CLIENT		
ABIB (OAMARU) LTD		
PROJECT		
GOODLAND COASTAL FARM		
TITLE		
EROSION & SEDIMENT CONTROL ADJACENT TO WETLAND		
DRAWN	TG	SCALE A1 1:25
DESIGNED	TG	A3 1:50
PROJECT No 1366	DRAWING No C227	REVISION A

To: Zoe Avery - The Urbanist
From: Zibo Yang - Crang Consulting
cc: Hari Hari - Goodland
Date: January 31, 2024
Re: 2127 Kaipara Coast Highway – Formal S92 Response – Rev 1

The following responses address items relevant to civil engineering within the Section 92 request letters. The queries responded to herein are cited in italics for ease of reference, with the corresponding response below. Each question retains the same number and wording as in the letter for ease of reference.

CLIENT		
ABIB (OAMARU) LTD		
PROJECT		
GOODLAND COASTAL FARM		
TITLE		
TEMPORARY STREAM DIVERSION WORKS		
DRAWN	TG	SCALE A1 1:100
DESIGNED	TG	A3 1:200
PROJECT No 1366	DRAWING No C477	REVISION A

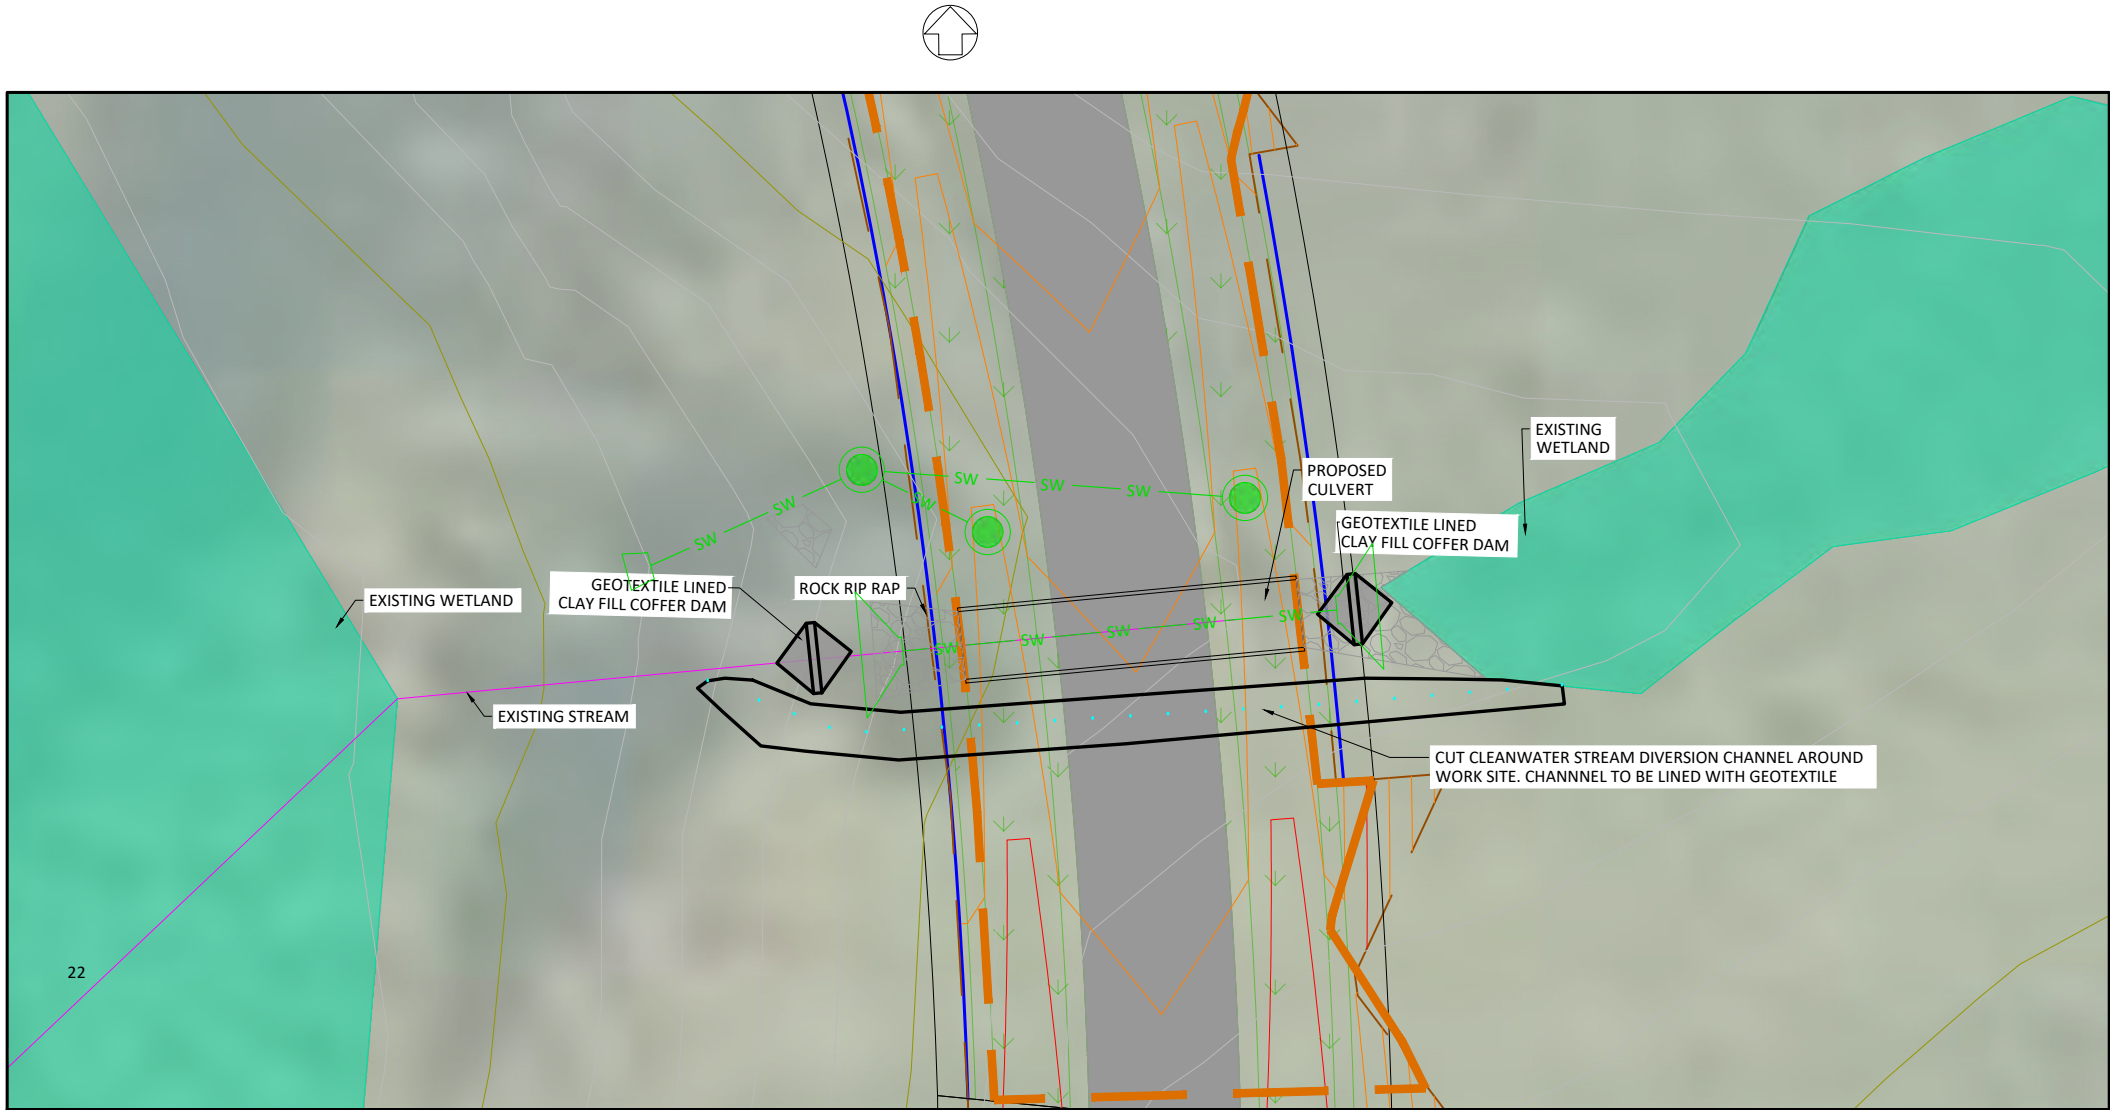
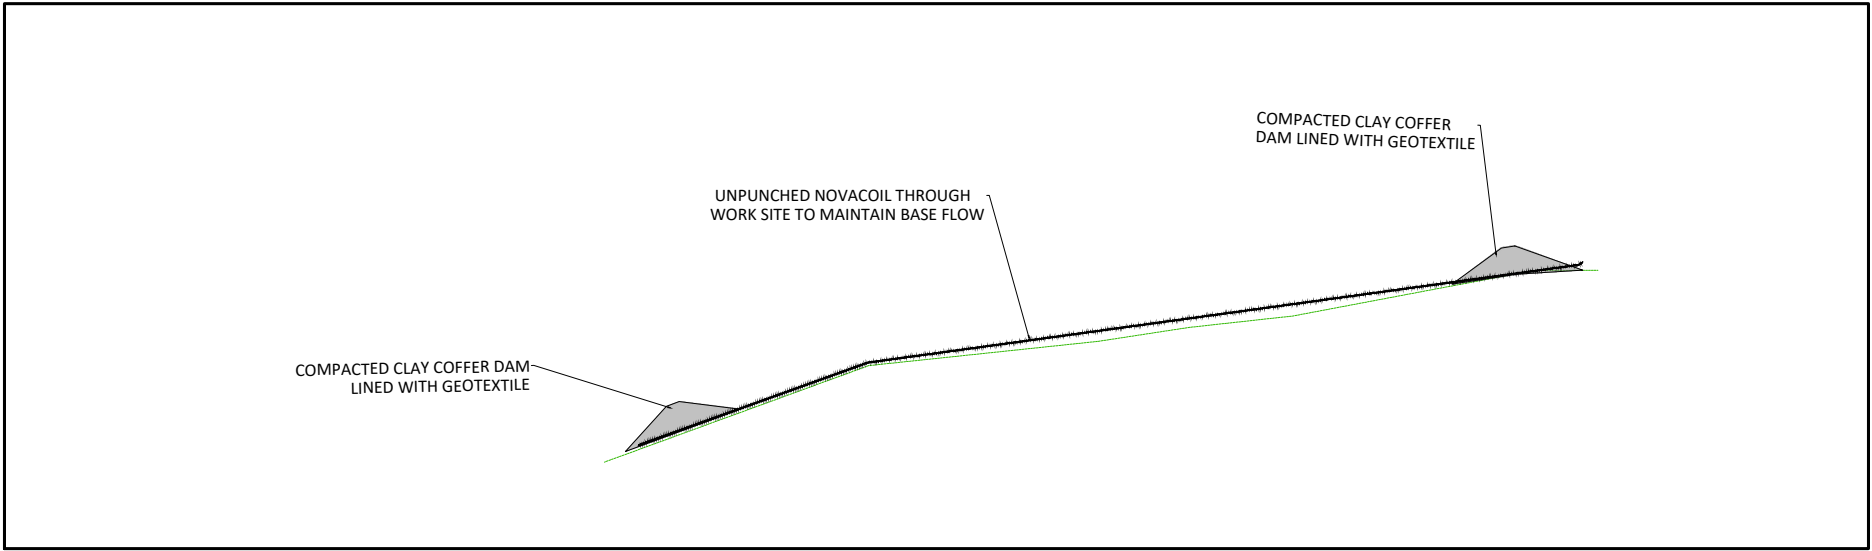
Query No. 65: For all in-streamworks, please provide a streamworks methodology to confirm compliance with the relevant permitted activity standard that relates to such works being carried out in accordance with best practice erosion and sediment control measures to minimise any discharge of sediment.

Crangcivil drawing C477(Rev A) illustrates the temporary stream diversion works for culvert construction mentioned above.

EXISTING AND PROPOSED
FEATURES PLAN

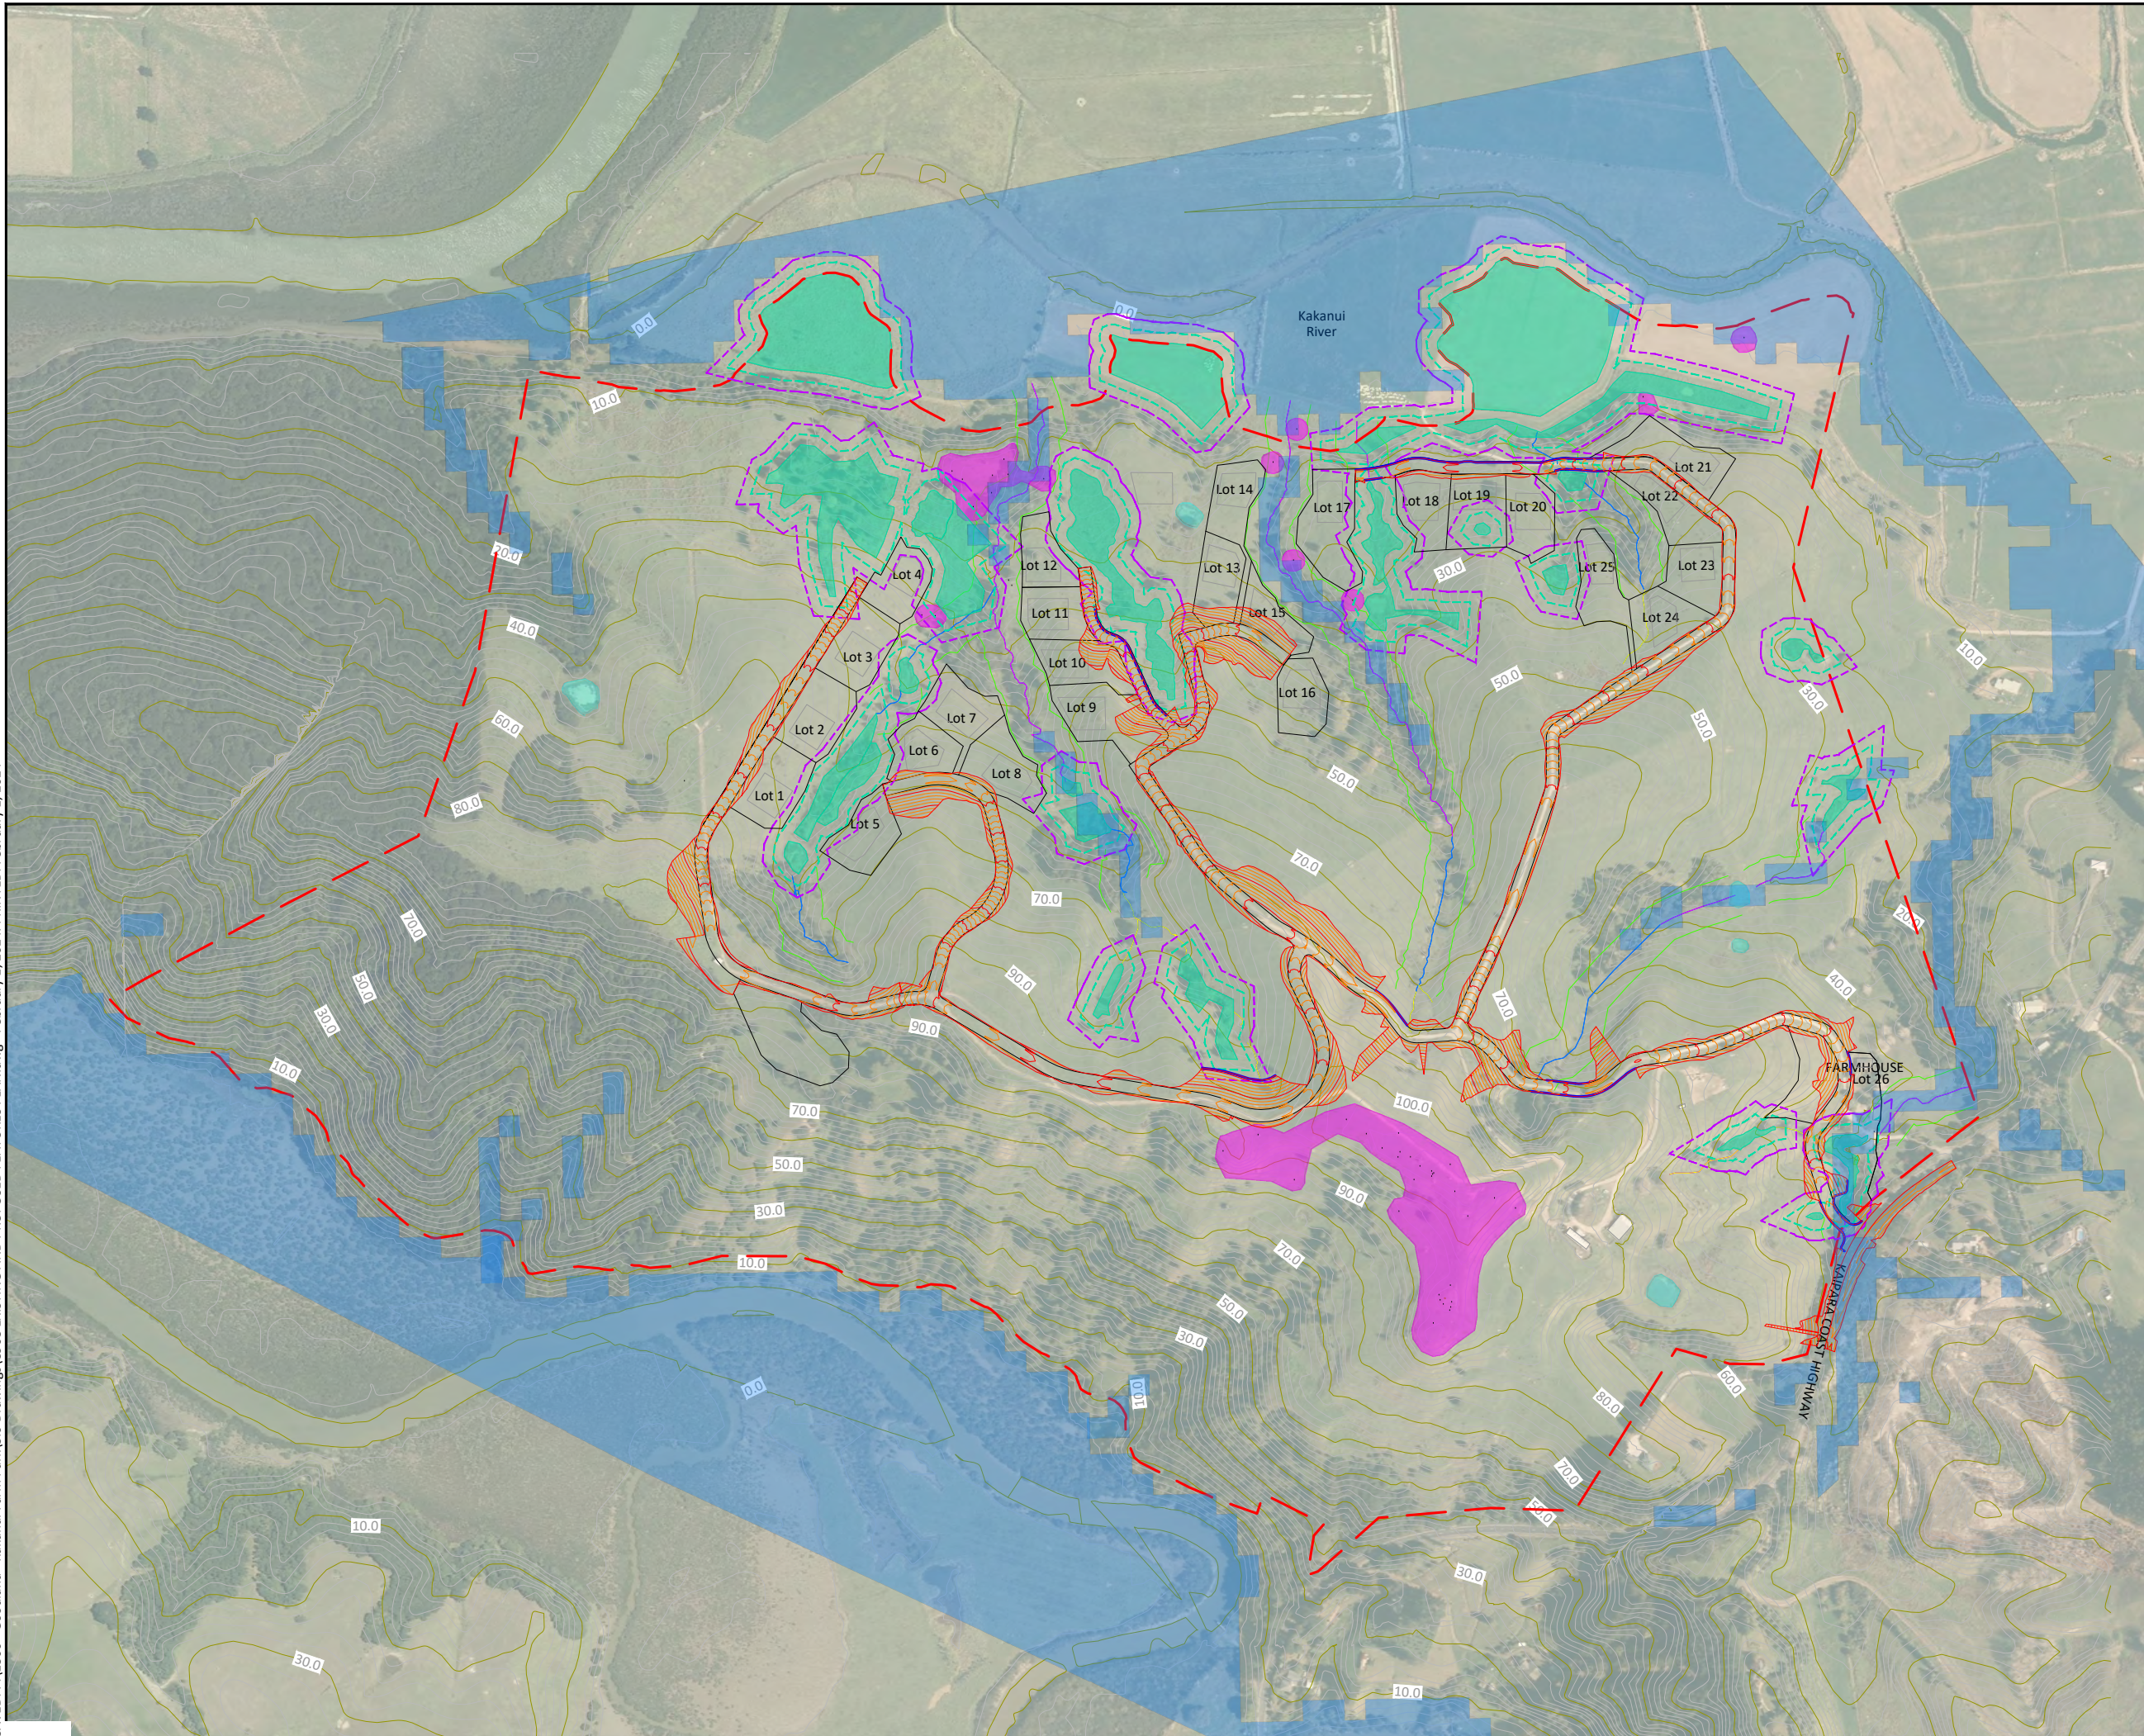
Query No. 15: *Please provide a plan that identifies all natural features on the site, the proposed earthworks, lot boundaries and roads. Crang Civil Plan 900 and the Wildlands Appendices are noted however this request seeks to understand what works are proposed in relation to each specific feature, associated setbacks etc.*

A new engineering plan 908 has been prepared to include the natural and proposed features such as proposed earthworks, boundaries, roads/accessways, as well as existing streams, wetlands, archaeology extents and associated setbacks from streams and wetlands. For other features such as vegetation habitat, please refer to Wildlands's drawings.
